## 4.9 LOGIC CONTROL DETAILS - CONTINUED.

Figure 3 PC Board Layout.

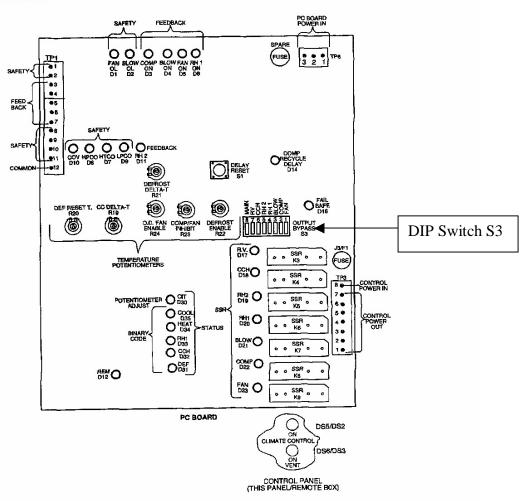
Note that LED D18 (CCH) and solid state relay K4 were removed from printed circuit (PC) board used on FDECU-4 and thereafter.
